STATE OF NEW YORK DEPARTMENT OF PUBLIC SERVICE

Re: Case 80008 - Information Requests Relating to
Aesthetics at the New Haven Area;

CASE 80008 - Information Request Relating to Aesthetics at the New Haven Site, 16 NYCRR PART 77.

CASE 80008 - Information Requests Relating to Geology and Seismology in the New Haven Area, 16 NYCRR Part 76.

FIGURE 4-3 NEW HAVEN SITE
OFF-SITE PIPELINE ROUTE
NEW YORK STATE ELECTRIC & GAS CORPORATION
CONSTRUCTION DIVISION, NEW YORK - 1963

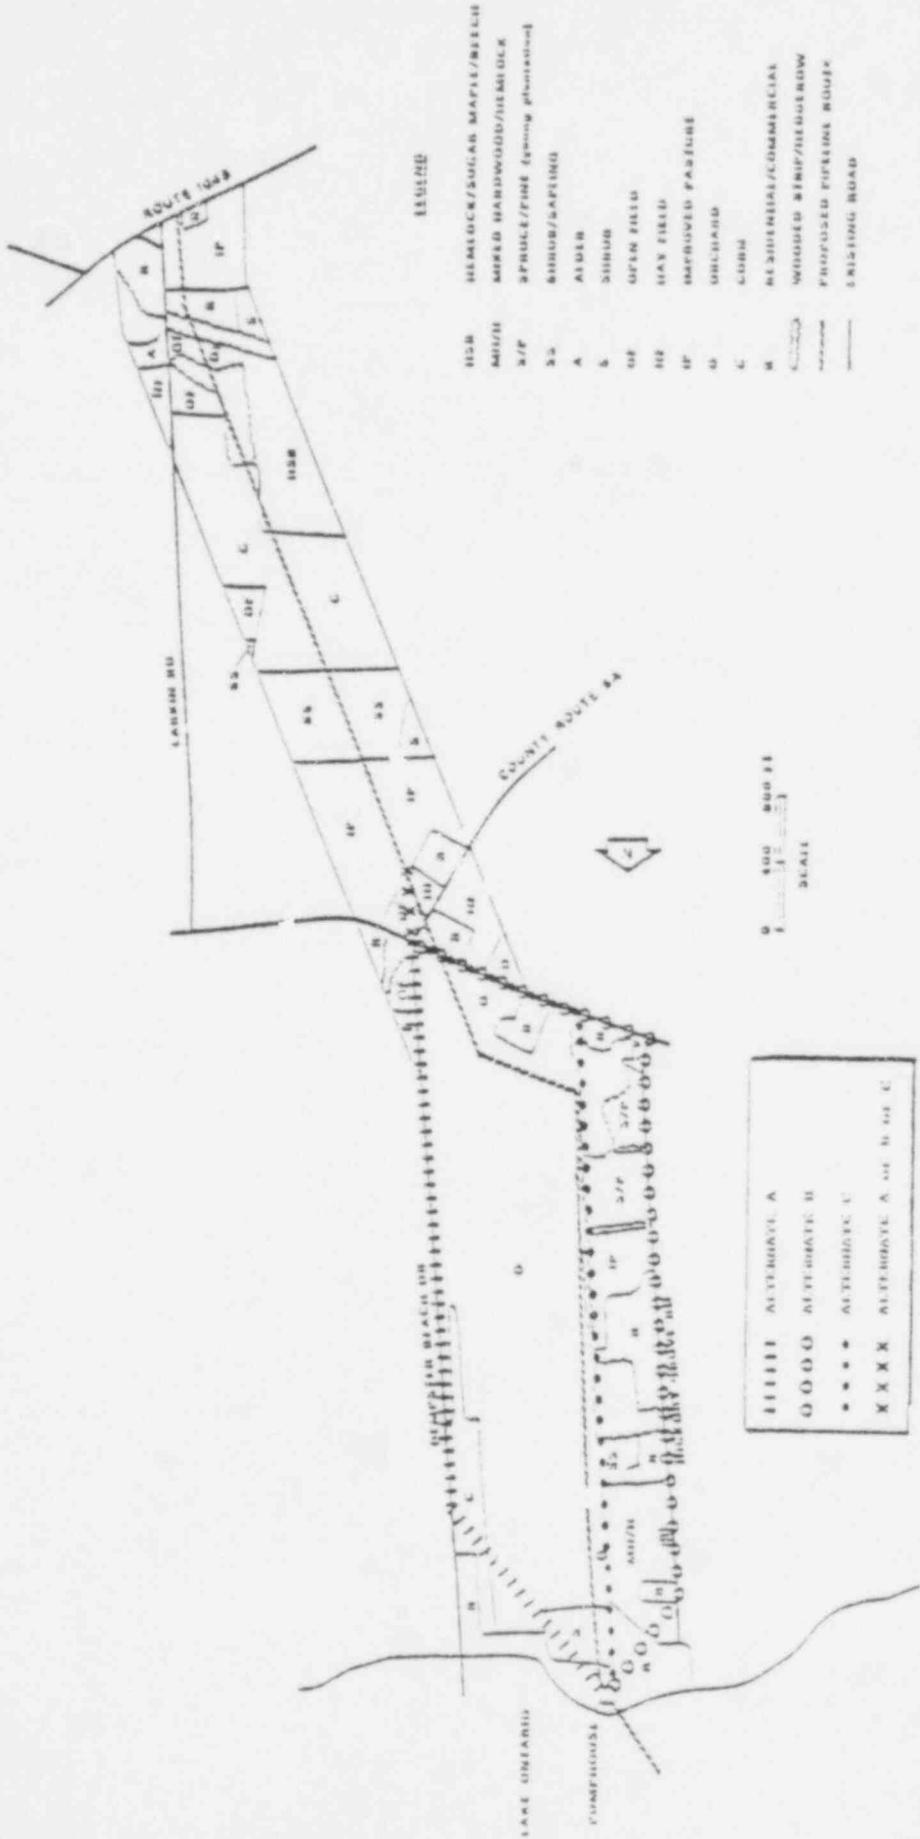
77-26 Section 4.1 and Figure 4.1-4 of the application indicate that the off-site pipeline route will go through an orchard between Dempster Beach Drive and Hickory Grove Road. Please discuss:

- a. The extent of clearing of 6-9 acres of the orchard, i.e., approximate number, age and average yield of the fruit trees.
- b. The time periods when this area will be disturbed and the effect of construction on the activities on the entire orchard, i.e., the ability of the farmer to move through the orchard in a normal course of his activities of pruning, spraying, harvesting, etc.

- c. The extent of disruption of sub-surface drain fields in access roads, if any, and the plans to restore these systems.
- d. The engineering, economic, land use and environmental costs and benefits of relocating this section of pipeline in a manner which will reduce the disruption of the orchard, e.g., along the Dempster Beach Drive right-of-way, or further to the west of the edge of the orchard.

f. Has the applicant considered the two alternate routes as indicated in the attached reference Figure 4.1-4? What are the advantages and/or disadvantages to each of these alternate routes?
